# INFORMATION SÉCURITÉ

Réf : 2025.0277

**OBJET : CONTRÔLE DE LA MODIFICATION DES SUSPENTES DE COMMANDE DE FREINS SUPÉRIEURES DES VOILURES SAFIRE 3 DE SUPERFICIE INFÉRIEURE OU ÉGALE A 169 PIEDS CARRÉS**

**Service bulletin number:** 20180301-V2

## SAFIRE 3 modification guide

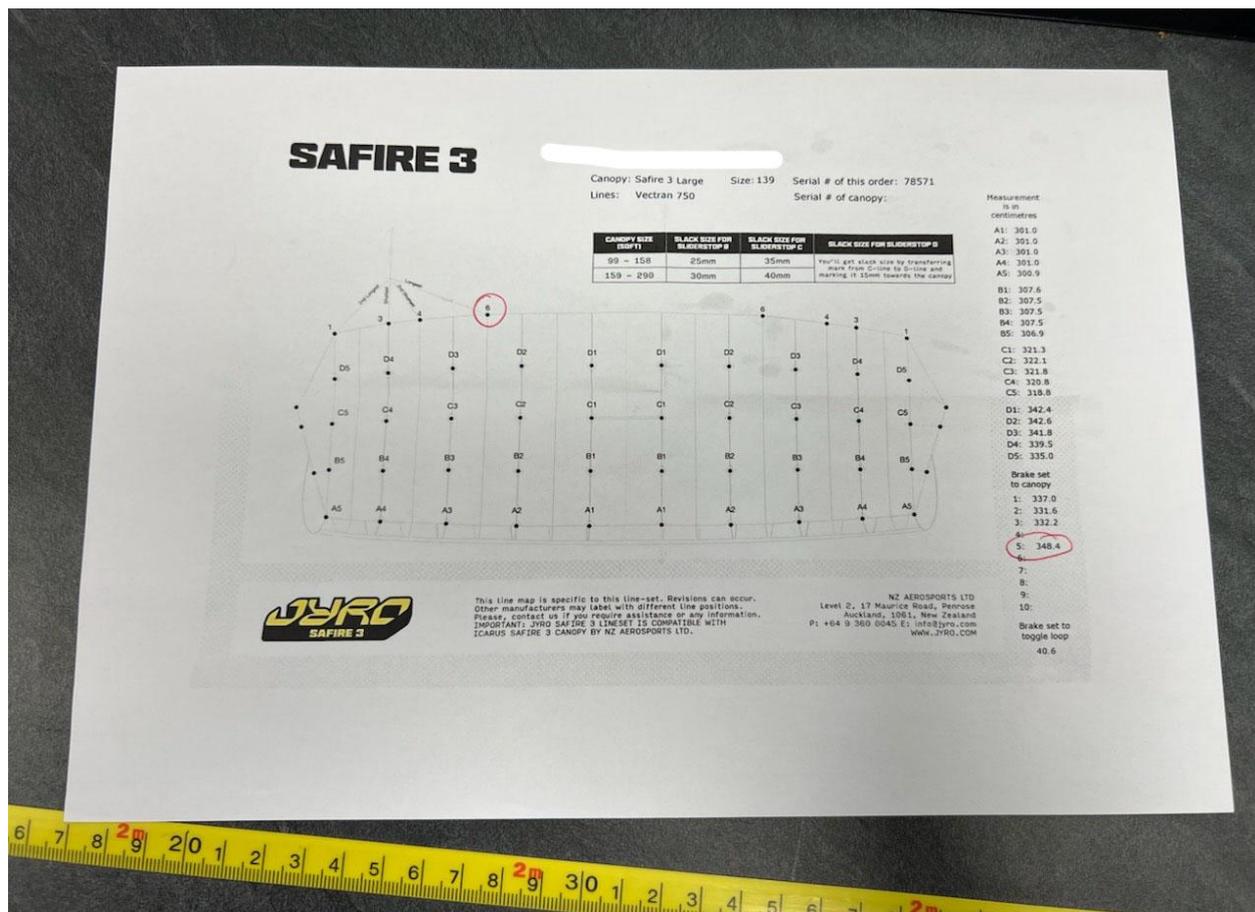
The modification includes reline and following change of brake tabs configuration:

- remove the existing line tabs from positions 4 and 6 on the tail;
- add new line tabs to positions 2 and 5 to match the "New" diagram.

Note: Brake tab positions are every rib, starting with the outside corners of the tail as position 1

**Bartack:** 42 stiches, centre start and stop

**Thread:** Tkt 60 (tex 45), Silver, bonded continuous filament nylon 6.6

● SAFIRE 3

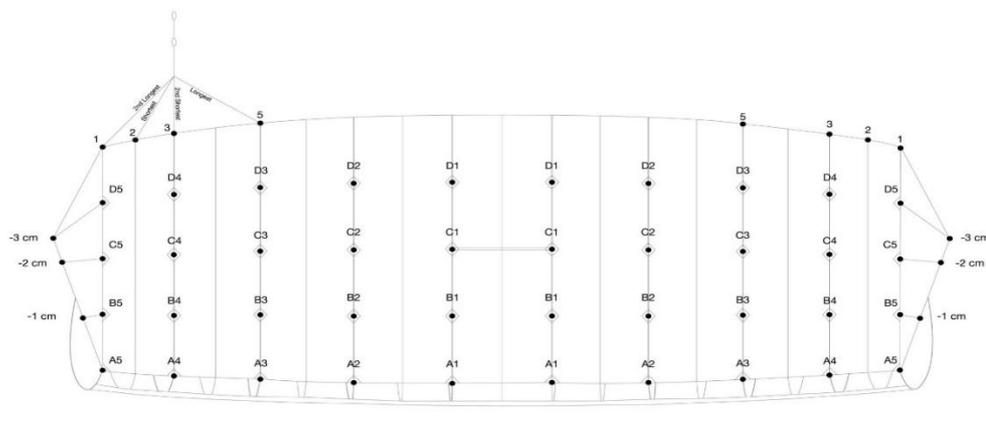
Apporter une attention particulière sur le schéma de montage de toutes les Safire 3 qui doit répondre à cette disposition

1. Brake Tab Configuration
  - a. Confirm that the canopy's brake tabs follow this sequence: 1-2-3-5 (see diagram below)
2. Lineset Check
  - a. Verify that the canopy has been relined with the current lineset
  - b. Quick tip: Measure A1 and A2 lines - they should be the same length in the current trim
